REZ-2025-102340

DRB III Trucking LLC

Report Drafted June 15, 2026

I. Executive Summary

EXHIBIT 'B'

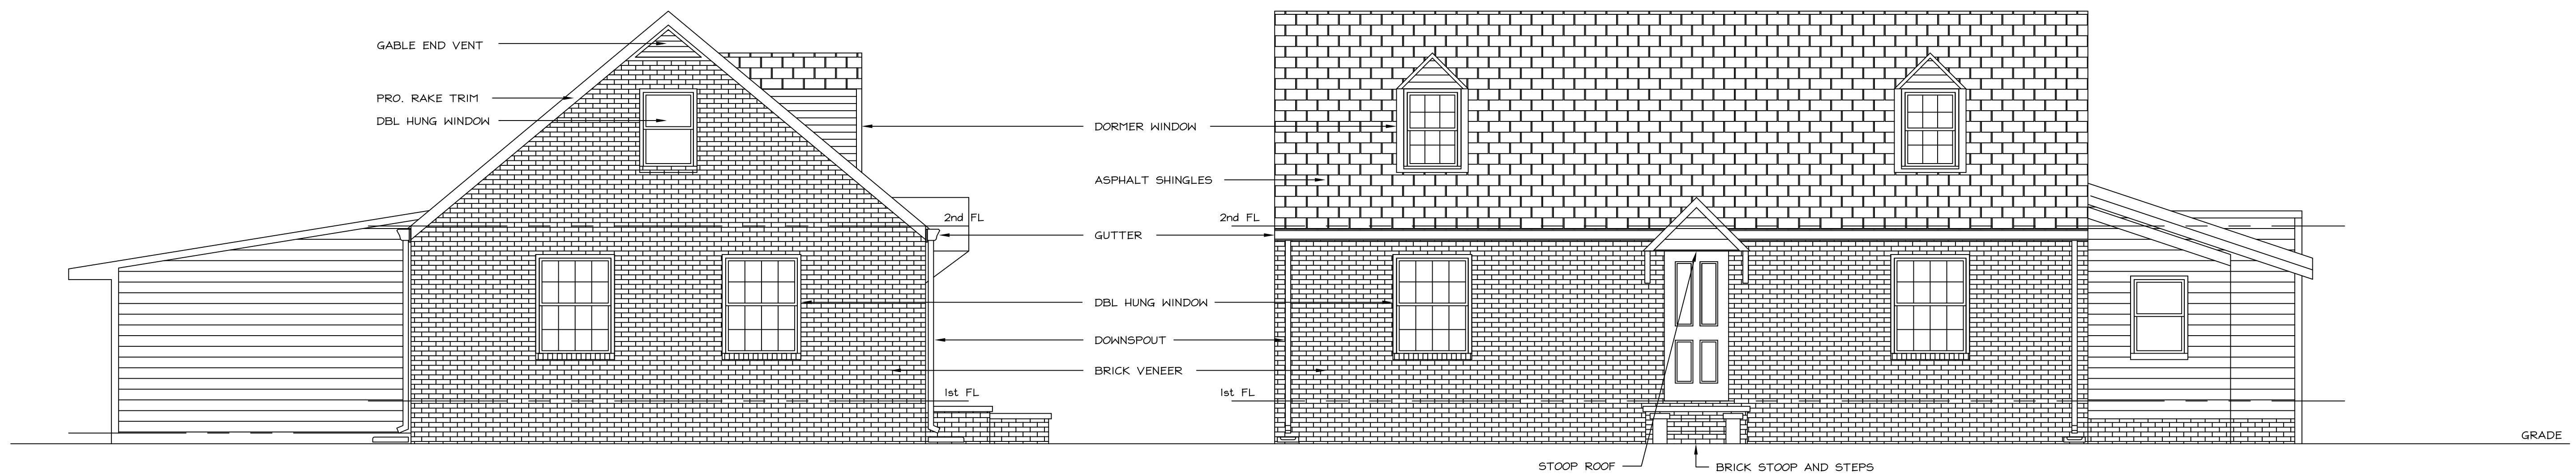
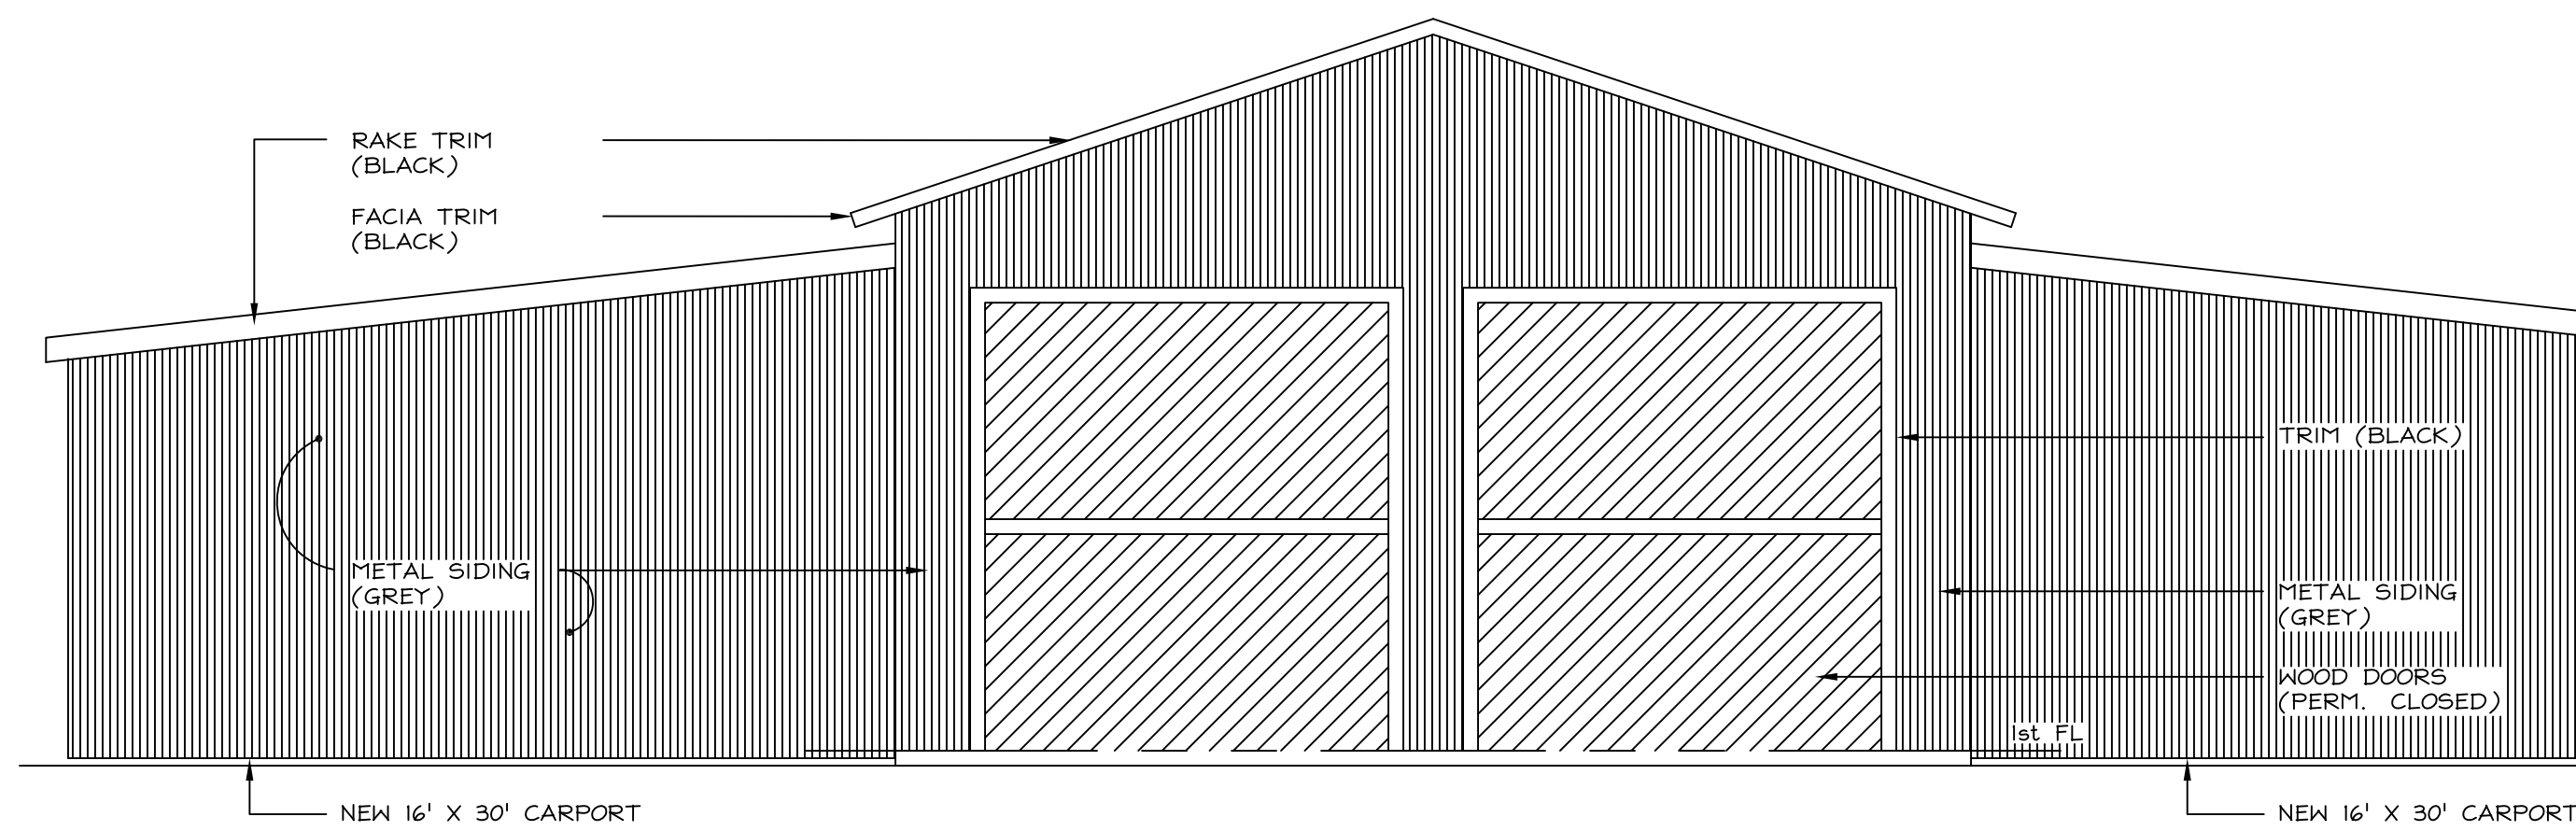
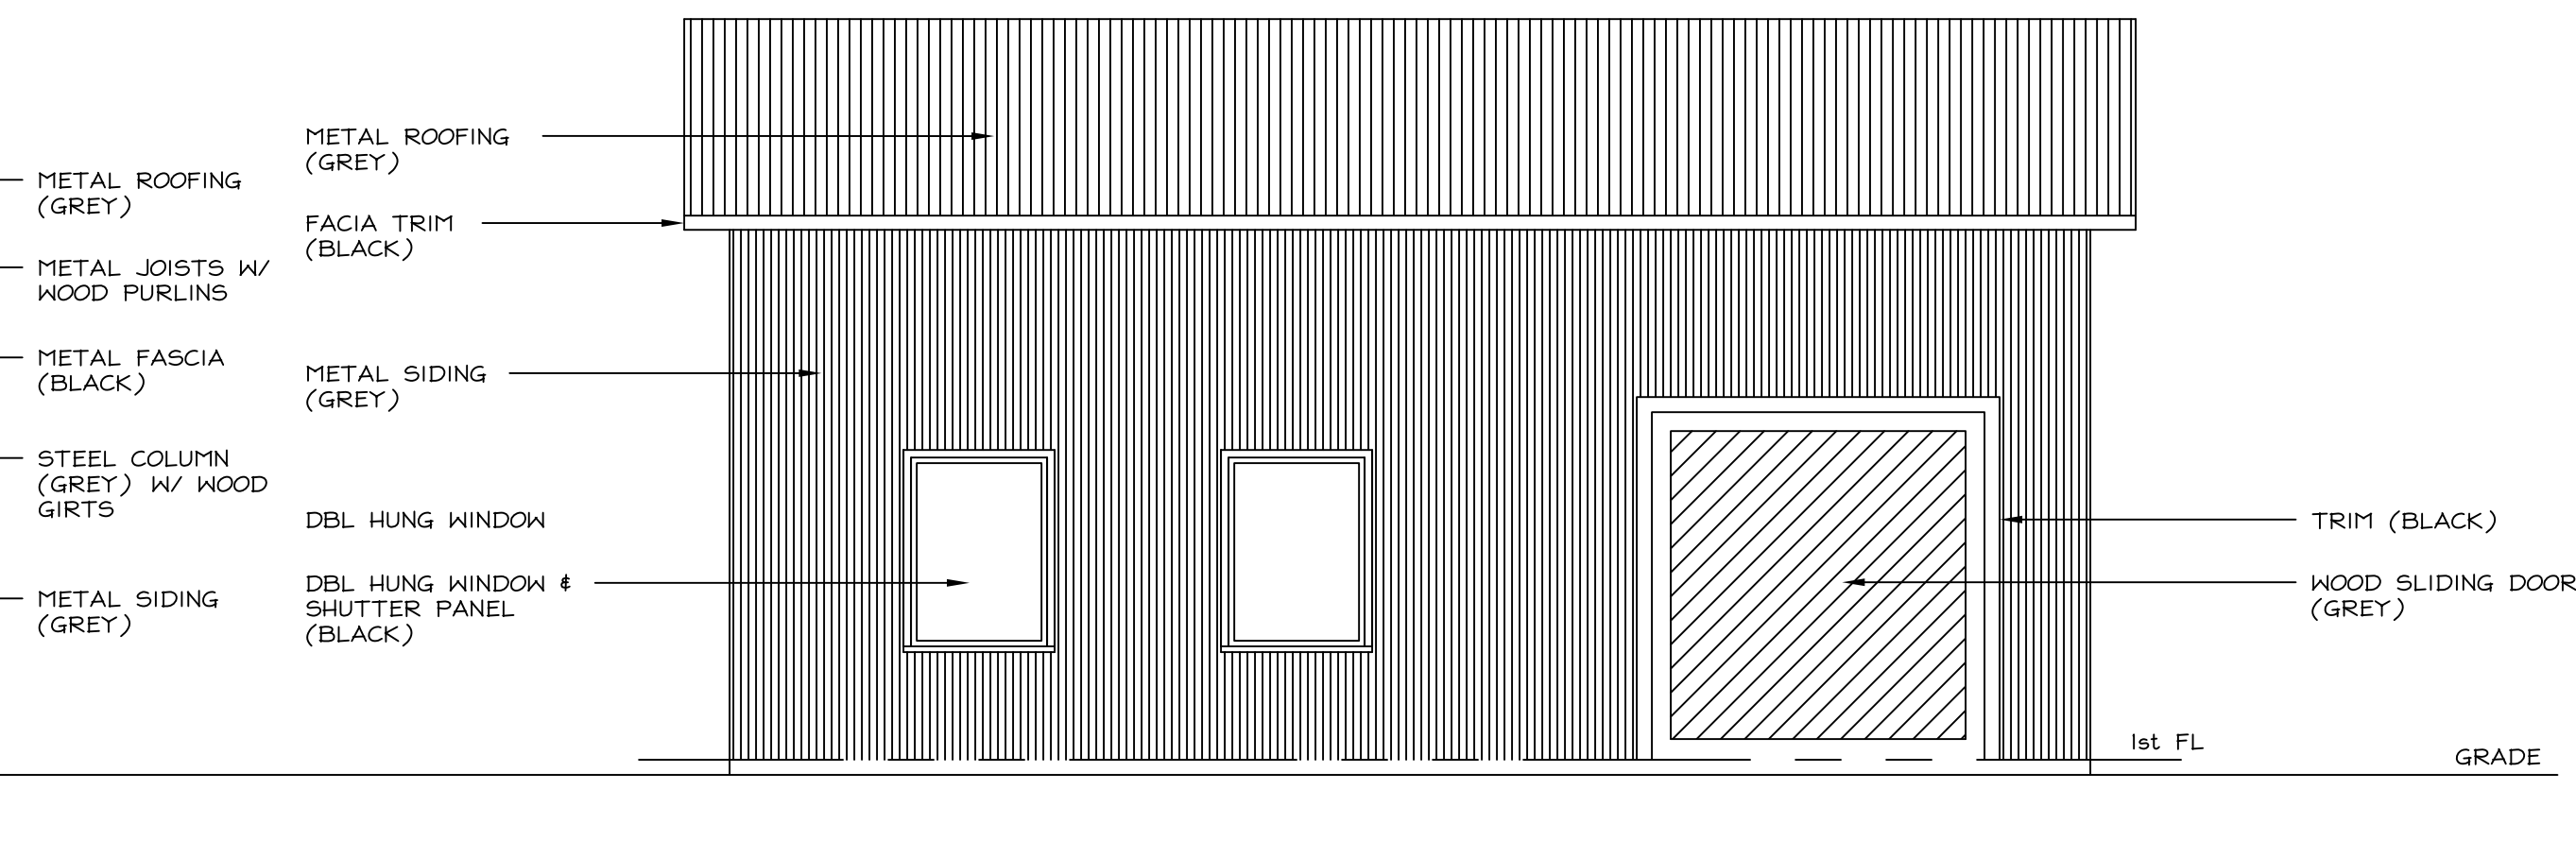
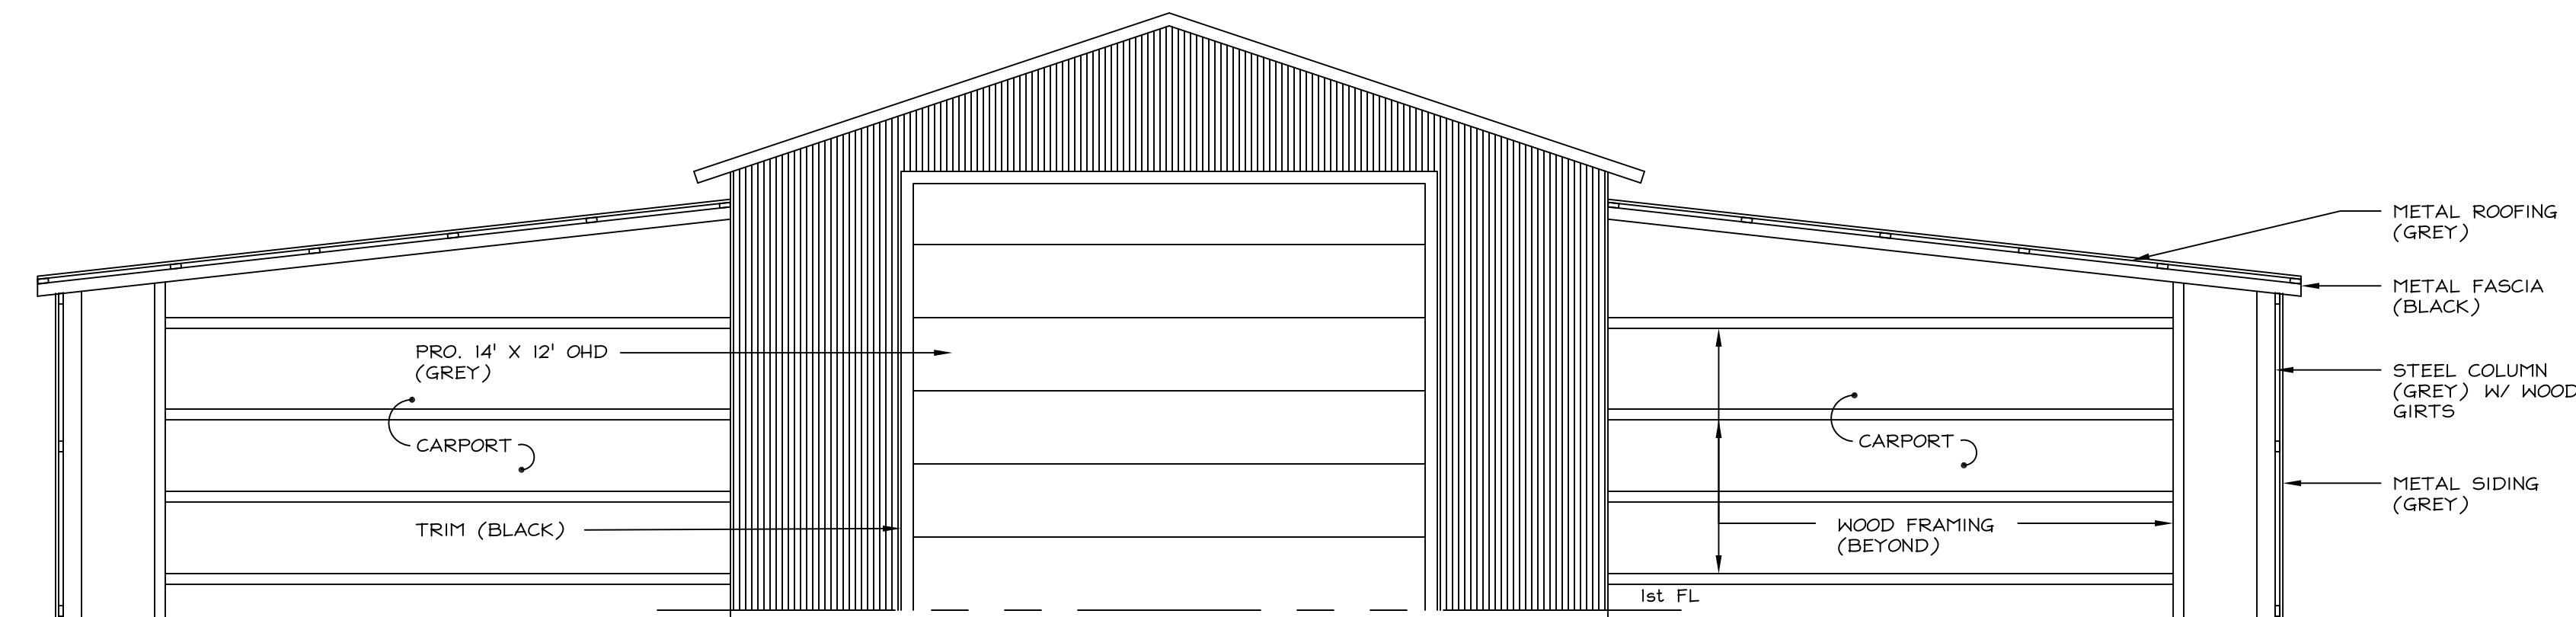
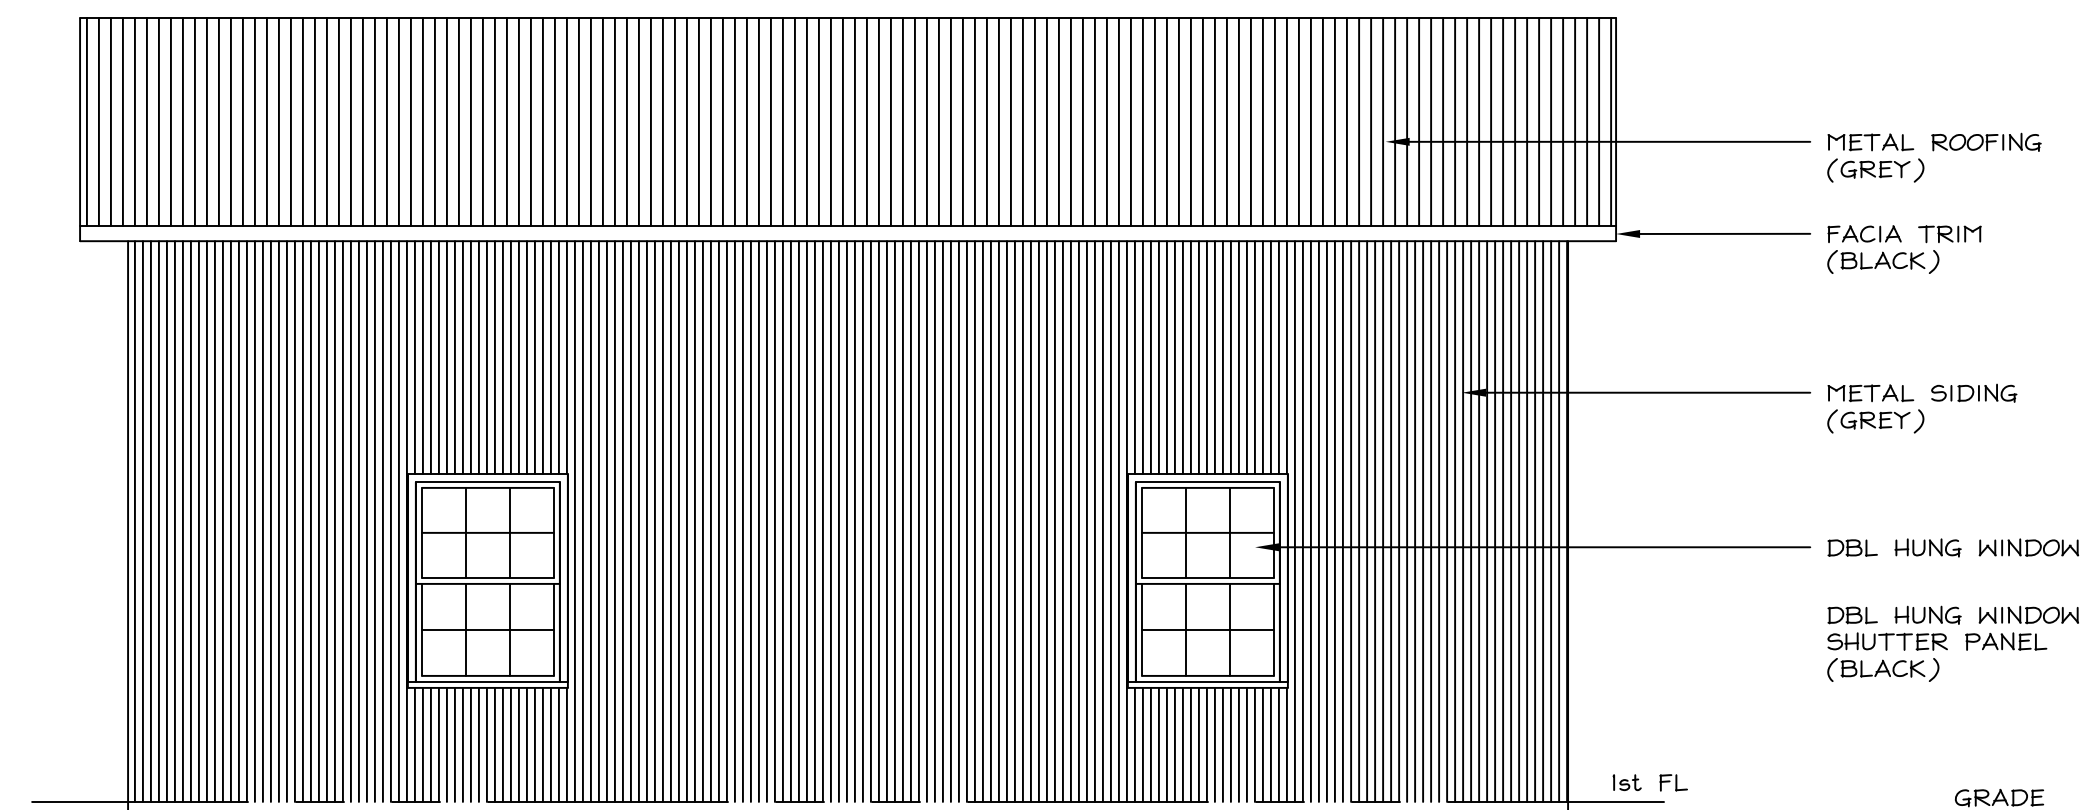
- **Building Elevations** – Minimal proposed improvements are noted on the elevations and while a building elevations proffer is provided, it does not include assurances for the installation or maintenance of the improvements consistent with Planned Industry;

- **Building Materials** – Building materials are noted on the elevations, but the proffers merely state the current finishes and do not include assurances of installing or maintaining quality exterior materials consistent with Planned Industry;
